UNITED STATES ENVIRONMENTAL
PROTECTION AGENCY
REGION IX
75 Hawthorne Street
San Francisco, CA 94105

March 16, 2020

Re: Response to Corrosion and Metal Fatigue Practices, Destructive Testing Results Report, Red Hill Bulk Fuel Storage Facility (Red Hill), Joint Base Pearl Harbor-Hickam, Oahu, Hawaii

Corrosion Report on Red Hill Bulk Fuel Storage Facility

Figure 1: Bulk and surface pH of concrete corresponding to the removed steel coupon plates. Bulk pH data and surface pH from DT Results Report [1].

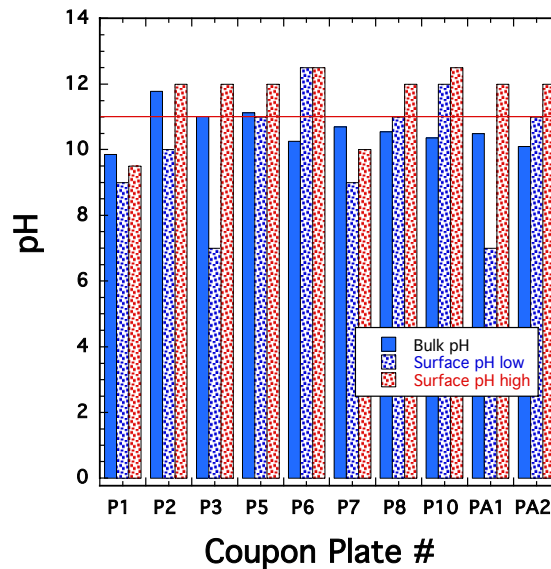
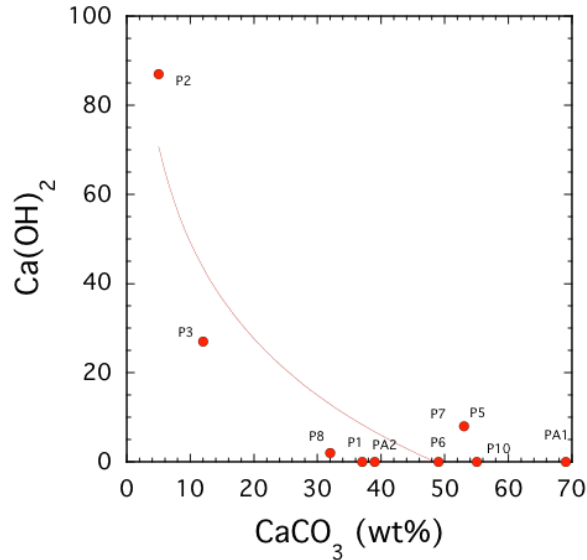
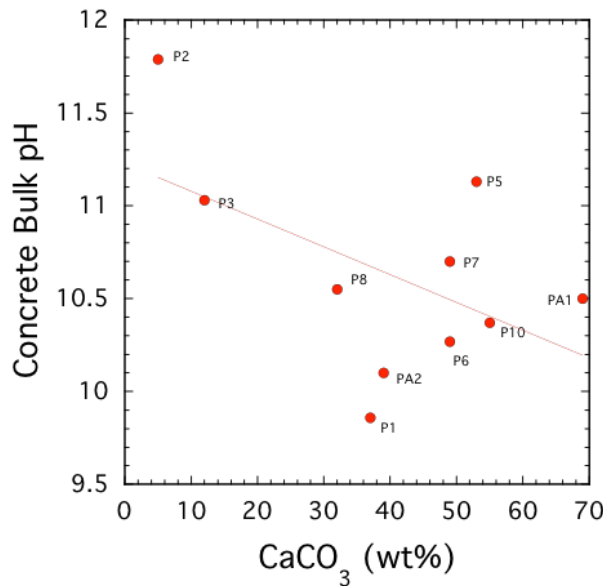
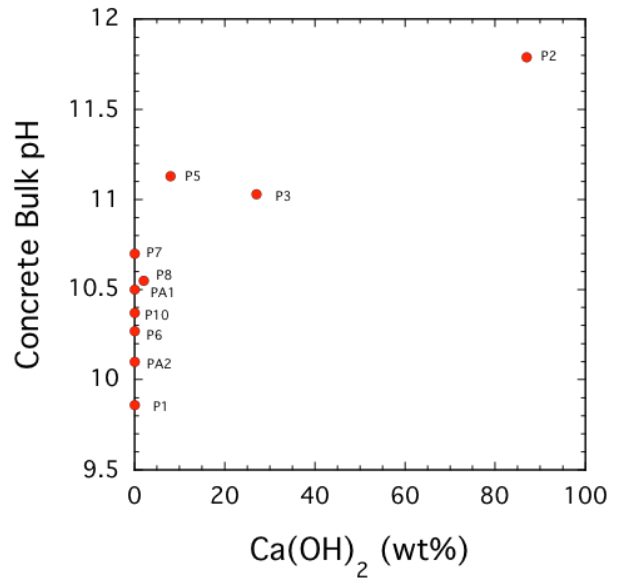
X-ray diffraction results (Table 2) [1] of the concrete powdered samples showed an average calcium carbonate content of 40.0 wt% with a standard deviation of 19.7%. The large variation in concrete composition (Table 2) could be accentuated by the small sample size. The general trend of increasing calcium carbonate with decreasing calcium hydroxide (Figure 2) was also observed. The origin of the high levels of calcium carbonate is not exactly known, but could be the result of carbonation, where carbonic acid from dissolved CO₂ gas in water reacts with calcium hydroxide in the concrete to form calcium carbonate [5]. This reaction can generally increase the strength of concrete [4, 6], but decrease its alkalinity and adversely affect the

corrosion resistance of imbedded steel [4]. The pH measurements coupled with the X-ray diffraction results [1] showed 1) decreasing concrete bulk pH with increasing calcium carbonate (Figure 3) and 2) decreasing concrete bulk pH with decreasing calcium hydroxide content (Figure 4).

The alkalinity of pore solution in fresh cement and concrete is approximately pH 13 – pH 14 [4]. As the concrete ages, the alkalinity is maintained at the pH 12 - pH 13 level [5] until the calcium hydroxide is consumed by the carbonation reaction. Once the calcium hydroxide is consumed and calcium carbonate precipitates, the pH drops further to levels where imbedded steel can corrode [4, 5]. In non-carbonated, highly alkaline concrete, the corrosion rate of steel is extremely low [4]. When the pH of the concrete falls below approximately pH 11, however, such as by carbonation, corrosion rates begin to increase [7] and passivation is lost at approximately pH 10 [3, 5]. The plot of pH values (Figure 1) shows that many values dropped below pH 11, where plain-carbon steel begins to lose passivity and its corrosion rate begins to increase [3, 5, 7].

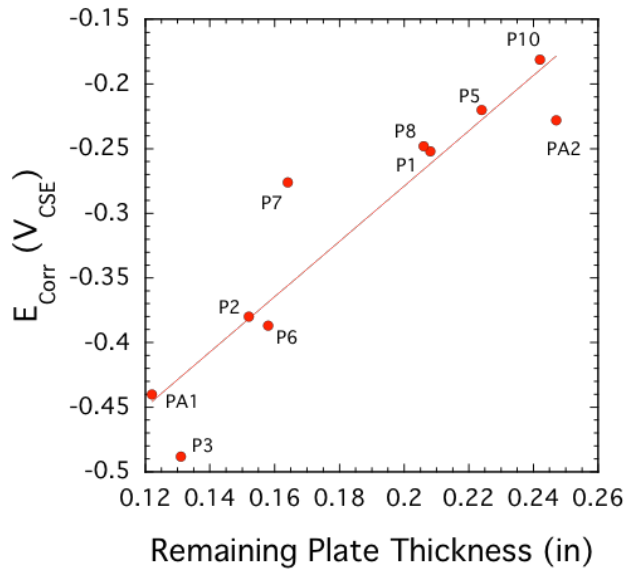
Of the potential measurements corresponding to the back side of the tank wall, only one potential was more positive than -0.2 V_{CSE}, indicating low probability of corrosion; five potentials were in the potential range of -0.20 to -0.35 V_{CSE}, indicating uncertainty of corrosion; and four potentials were more negative than -0.35 V_{CSE}, indicating high likelihood of corrosion. The reported minimum remaining plate thickness values for each plate was plotted vs the corrosion potentials (Figure 5), showing strong correlation. The more negative the corrosion potential (indicating a

higher tendency to corrode), the lower the measured remaining plate thickness. Plates P5, P10, and PA2 corresponding to the three most positive corrosion potentials ($> -0.23 \text{ V}_{\text{CSE}}$) showed no or only very light surface rust (Figure 6) [1]. Plates P1 and P8 (with potentials $\approx -0.25 \text{ V}_{\text{CSE}}$) showed mostly mild surface rust (Figure 6) [1]; whereas, the remaining plates PA1, P2, P3, P6, and P7 (with potentials $< -0.27 \text{ V}_{\text{CSE}}$) showed significantly more severe rusting (Figure 6) [1].

Figure 6: The back side of the steel coupons, structure-to-electrolyte corrosion potentials (in V_{CSE}), and the minimum remaining thickness (in inches) that was measured for each plate. From DT Results Report [1]

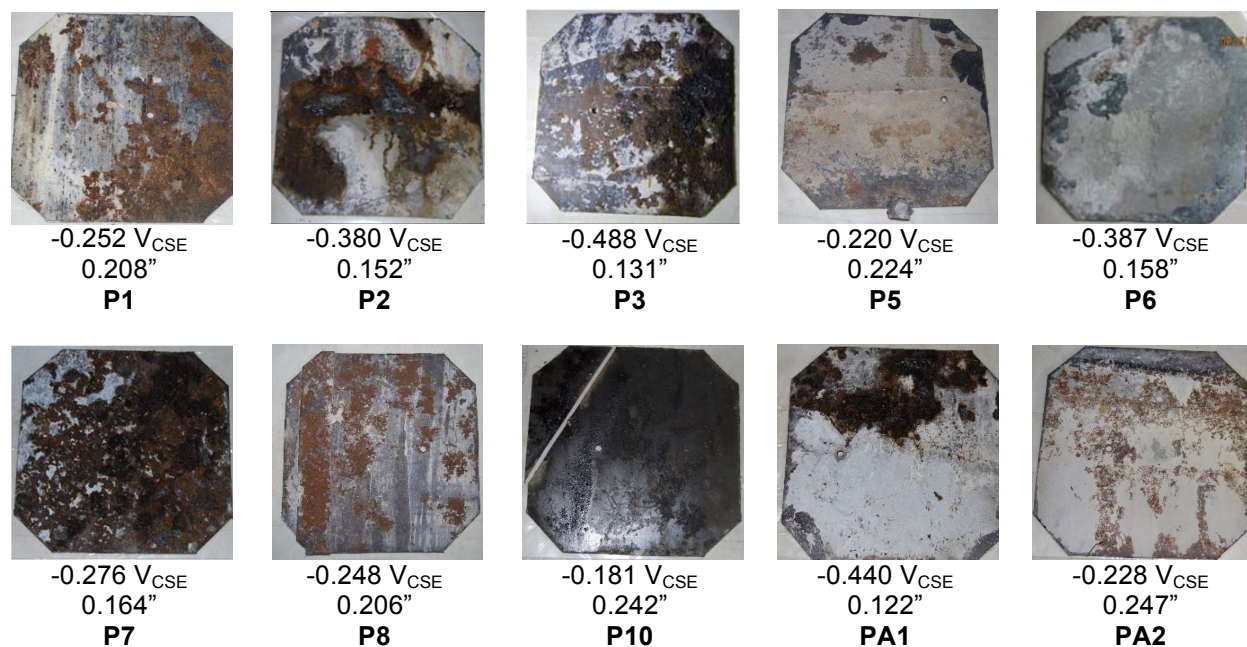
Generally, the formation of the visible red-brown rust (Figure 6) on plain-carbon steel indicates that the passivation in that local region has been lost. The gray regions of the plates (excluding the adhering concrete or grout) are regions where the steel is in the passive state (Figure 6). Passivation can be lost when the pH of the concrete drops below approximately pH 11 [7], or chloride (Cl^-) ions are present in sufficient concentration [4, 7]. The NACE Standard Practice SP0308-2008 [9] indicates that acid-soluble chlorides in excess of approximately 0.2 % (by weight of cement) can initiate corrosion of steel in concrete. The ion chromatography analyses of the concrete powder samples showed that the chloride concentration in the concrete ranged from 50 ppm (0.005 % by weight of cement) to 171 ppm (0.017 wt%), which is much lower than the threshold. The concentration of chlorides detected in the corrosion

products using energy dispersive X-ray analyses (EDXA), however, was significantly higher: The maximum value of 1.7 wt% (17,000 ppm by weight of corrosion product) was detected in the corrosion product of plate PA1; 0.6 wt% (6,000 ppm) in plates P2 and P7; 0.3 wt% (3,000 ppm) in plates P3, P5, P6, and P10; and none in plates P1, P8, and PA2. The detection limit of EDXA is on the order of 0.1 wt% (1,000 ppm). The maximum concentration of the chlorides in the corrosion products were up to approximately 100 times higher than the maximum concentration in the concrete. Chlorides at these levels as well as the drop in concrete alkalinity below approximately pH 11 are likely to breakdown passivation and cause increasing corrosion rates of the steel.

Figure 8: Effect of initiation phase on average corrosion rates (a). Remaining life (b) based on active and average corrosion rates and pit depth 1 (PD1).

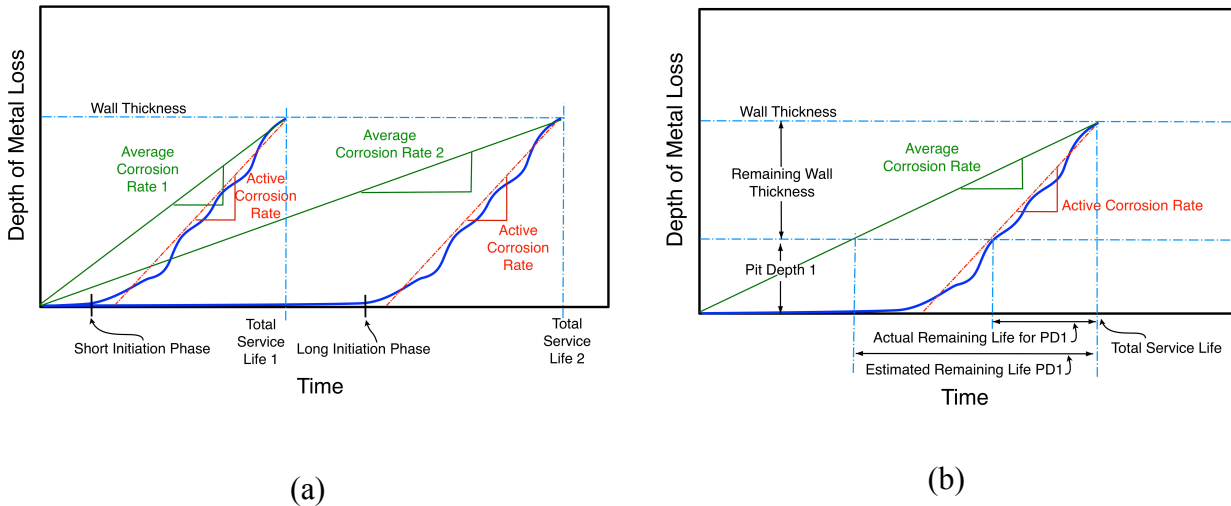
The higher historical corrosion rates could be associated with short initiation phases (Figure 8a) from regions where steel lost passivation in the early stages. Regions where the steel remain passivated and have long initiation phases (Figure 8a) will result in low average corrosion rates. Currently, any region of the tank that has back-side corrosion (i.e., rusting and remaining thickness less than the original plate thickness of 0.25") is likely not passivated, and in the propagation stage (Figure 7). To obtain an accurate remaining life before wall penetration, realistic corrosion rates are needed. Therefore, in regions of the tank that are no longer passivated, actual measured active corrosion rates or historical corrosion rate data with a short initiation phases (Figure 8a) are needed to more accurately estimate the remaining life

(Figure 8b). If corrosion rates based on long initiation phases are used, the actual remaining life could be grossly over estimated (Figure 8b).

Figure 11: Cross section of coupon plate P3 (a) at the area of maximum wall loss (p. 18 of DT Results Report [1]) out of four sections examined, and cross section of coupon plate P6 (b) at area of maximum wall loss out of three sections examined (p. 24 of DT Results Report [1])

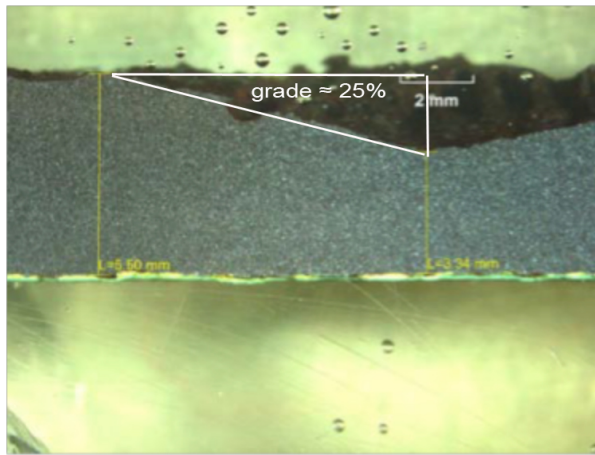
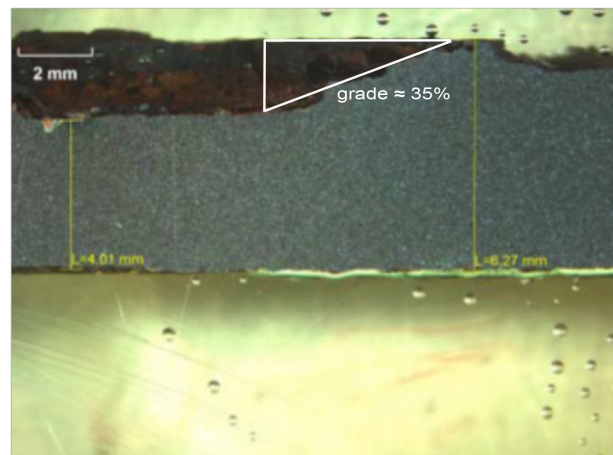
For coupon plates P3 and P6, a remaining thickness less than 0.200" was not expected (pp. 46 and 51 of DT Results Report [1]); however, the destructive testing showed minimum remaining thicknesses of 0.131" and 0.158", respectively, for coupon plates P3 and P6. The pit size and grade (Figure 11) were well within the detectable limits of the low frequency electromagnetic technique (LFET) [16], but these pits were not recorded. The DT Results Report [1] also showed that there were high levels of magnetite in the corrosion products ranging from 17 % to 84 wt% (Table 3). It has been reported in the literature [17] that when

Figure 12: Coupon plate P2. Possible deep pit in yellow box region not sampled. Original images from DT Results Report [1].

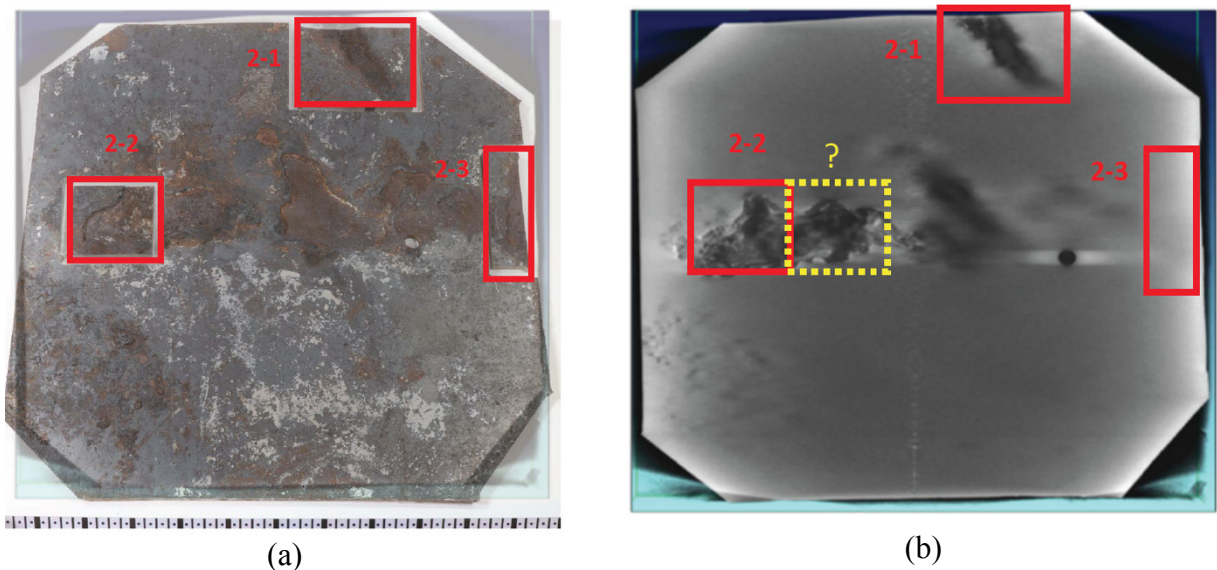
There are also concerns of whether or not the sites with the deepest pits were sampled during the destructive testing. The steel coupons were specified to be cleaned and subjected to three-dimensional profilometry (as specified on p. 8 of the DT Results Report, [1]) to document the

surface profile of the remaining steel substrate. The steel coupons were cleaned with a CO₂ dry ice blast, but all of the corrosion products were not removed; hence, the regions of the deepest pits would be difficult to determine. The three-dimensional profilometry data was not provided in the DT Results Report [1], but the results would likely not have characterized the bare steel substrate since the corrosion products were not thoroughly removed. X-ray computed tomography (CT) was used to aid in selecting the regions with the deepest pits, but in some cases, regions with potential deep pits were apparently not sampled (e.g., Figures 12, 13, and 14). The DT Results Report [1] did not describe if other methods were used to confirm the location of the deepest pits.

Figure 2-1 Schematic of Tank 14 Coupon Locations

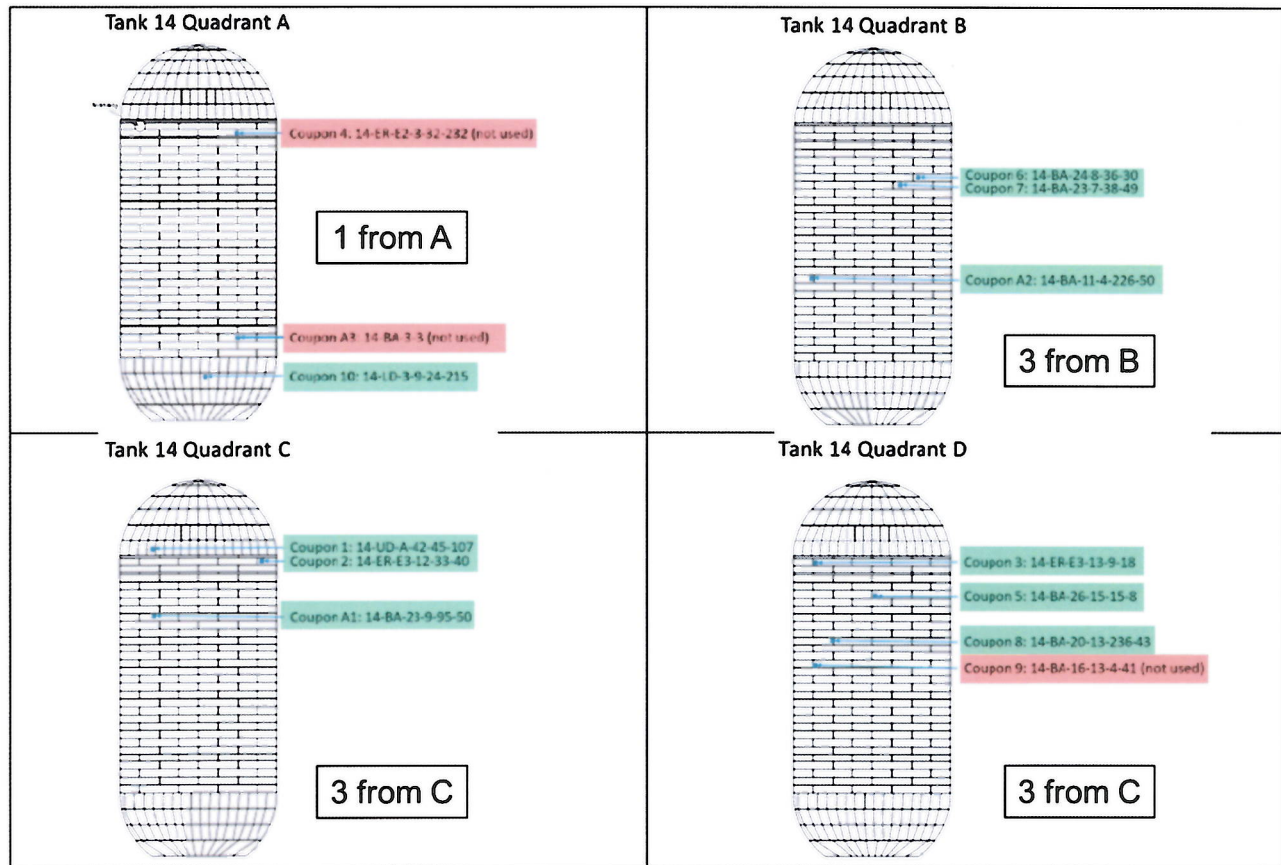
The Navy, however, did not follow its commitment in the DT SOW and instead selected a much less diverse range of coupons that are unlikely to be representative of the potential conditions

within Tank 14 much less the conditions of all the tanks at the RHBFSF. Ultimately, the Navy extracted eight coupons from the tank barrel (i.e., the vertical walls), one from just inside the upper dome, and one from sloped section of the lower dome; shown below for the locations marked in green. The locations marked in red were identified as possible coupon locations but were not extracted. The BWS is not aware of any random locations selected based on the BFET scans specifically to assess the welds. The Navy's description of the NDE result at these coupon locations do not discuss the BFET result at all. Further, the BWS is not aware of any coupons extracted from the lower dome bottom plate.

Figure 1 – Destructive Testing Cross-section from Sample 6-1

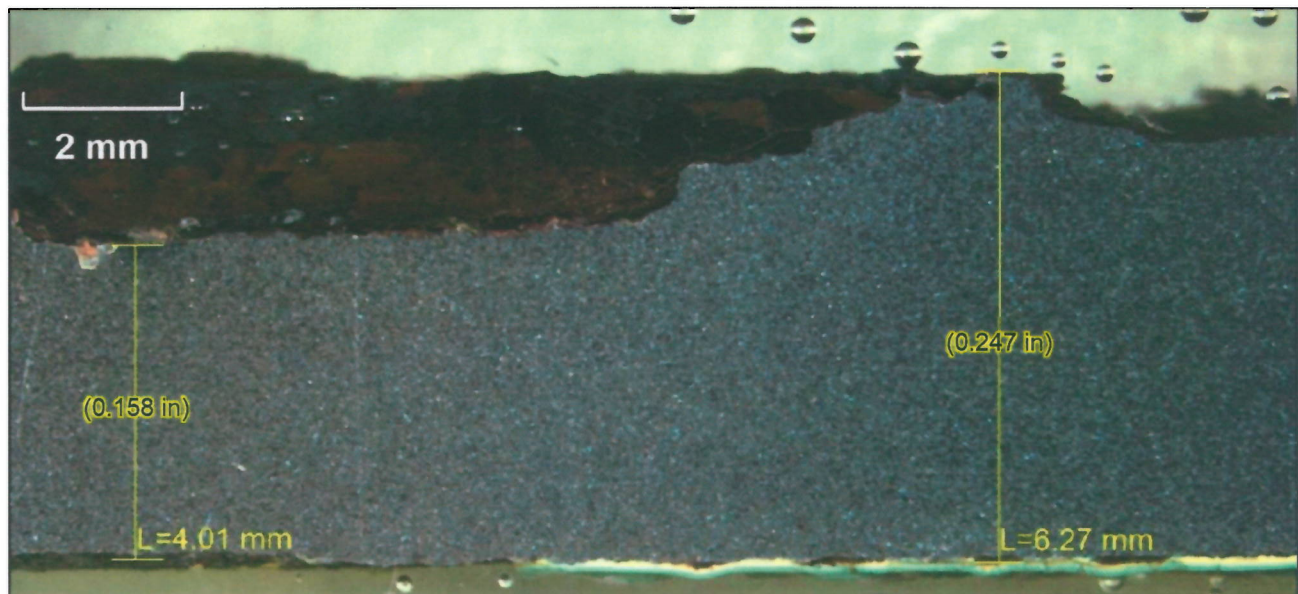
1. The larger, TesTex Falcon Mark II 2000 device should have been able to detect the pit in Coupon 6. According to the Navy this device has a probability of detection (POD) of 100% at 25% wall loss on pits with an aspect ratio of 3:1. The deepest pit in Coupon 6 amounted to ~37% wall loss and aspect ratio of greater than 3:1 (width to depth ratio). Figure 1 shows the cross-section through the deepest pit in Coupon 6 where the size and depth of the pit is obvious.
2. The smaller, TesTex TS-2000 device should have been able to detect the pit in Coupon 6 as the Navy stated this device can detect pits with a diameter of 1.57 mm. The width of the corrosion pit in Coupon 6 was much, much wider than 1.57 mm as is shown in Figure 1.

Second, the BWS believes Figure 1 clearly demonstrates this pit cannot be described as a “*pit of very small volume.*” This figure clearly shows a broad pit of considerable volume.

A similar figure was provided for Coupon 6 in Figure 1. The Navy's LFET and PAUT entirely missed the backside corrosion on Coupon 6, but the DT showed the minimum wall to be 0.158 inches thick. That is, DT demonstrated that this location should have been repaired, whereas both the LFET and PAUT NDE techniques indicated that the liner in this area was thicker than 0.200 inches.

Figure 2 -- (Image from: IMR Test Labs. 2018)

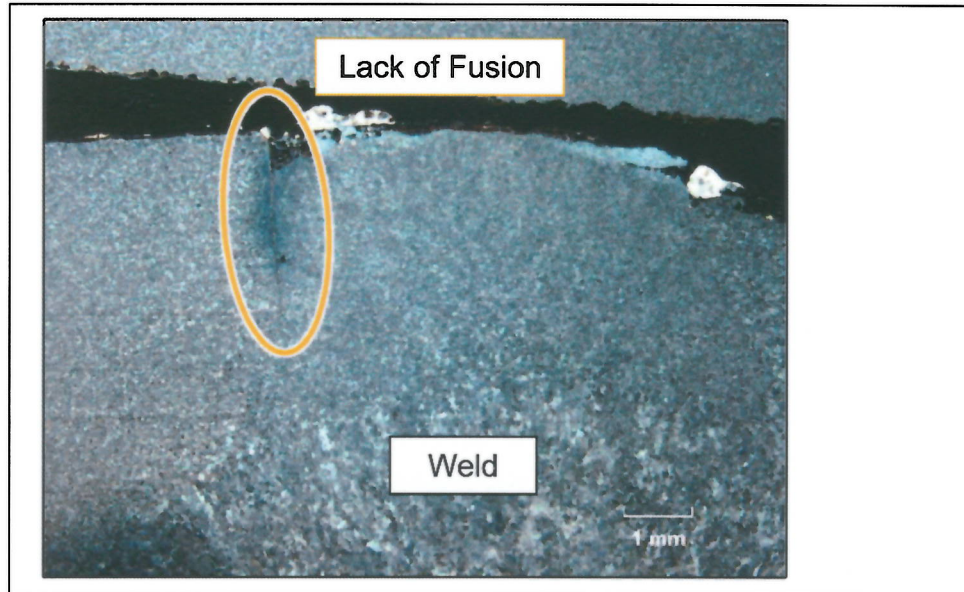
4. The DT inspection did find weld defects. The one coupon that actually had a weld contained a linear defect that was found by destructive testing. This lack of fusion linear weld defect is shown below.

Figure 4 – Relationship between NDE thickness estimate prior to DT and the actual remaining thickness determined from DT.

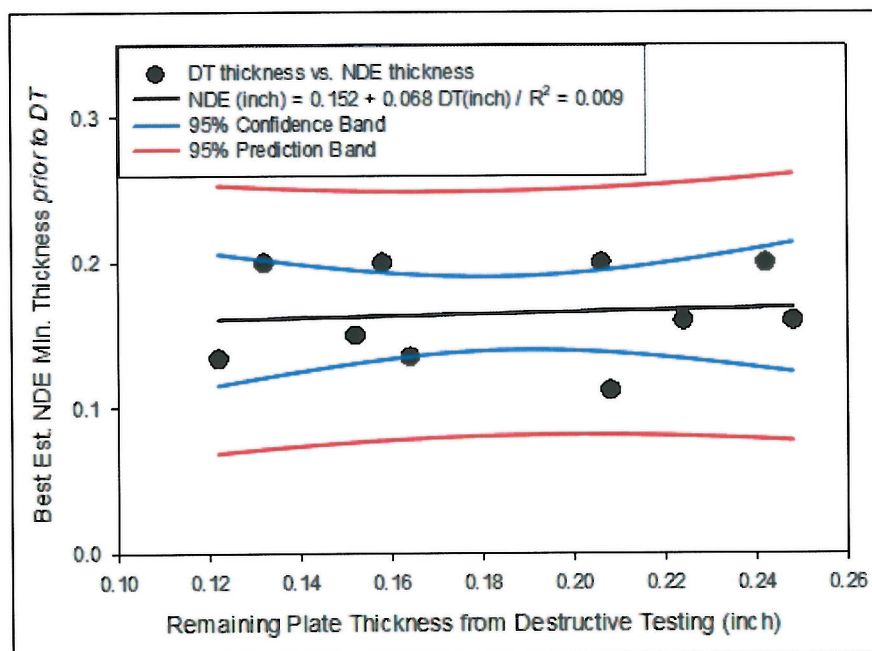
We have also plotted the actual minimum plate thickness determined from the DT against the best estimate of the coupon minimum thickness determined prior to the DT, Figure 4. To simplify, we conservatively assume the NDE-measured thickness in censored cases (i.e., the coupons for which thickness is reported as known only to be either greater or less than a specified value) were the specified bounding values. Similar analyses were also done for each NDE method treating those cases as interval-censored, and the results did not change significantly.

Figure 4 clearly indicates the NDE techniques are neither accurate nor reliable. First, the slope (0.068) of the line drawn through the DT vs NDE data is very flat (close to zero), indicating the NDE results are essentially insensitive to actual corrosion depth. For comparison, if NDE was perfectly accurate, then the DT thickness would be equal to the NDE thickness and the slope of the line drawn through the data would be 1.0. Instead, the calculated slope is consistent with what one would expect if the NDE results were simply chosen at random without regard to the actual coupon thickness. Another indication is the coefficient of determination (R^2), which measures NDE accuracy by comparing the variation in NDE results to the residual variation after accounting for the actual coupon thickness (using the regression line). As noted in Figure 4, the R^2 value is effectively zero (0.009), indicating none of the observed variation in NDE-measured thickness is attributable to corresponding variation in the actual thickness of the test coupons.

Finally, the figure includes plots of the 95% lower and upper prediction bands, which are very broad. For example, for a coupon with an actual remaining wall thickness of 0.12 inch, with 95% probability the corresponding NDE-measured thickness will fall between 0.070 and 0.25 inch (the values at which the lower and upper bands, respectively, intersect the vertical line at 0.12 inch). The bands vary little over the range of coupon thickness studied. Thus, for any actual tank wall thickness, the NDE-measured thickness can be reasonably expected to range from effectively no damage to severe damage.
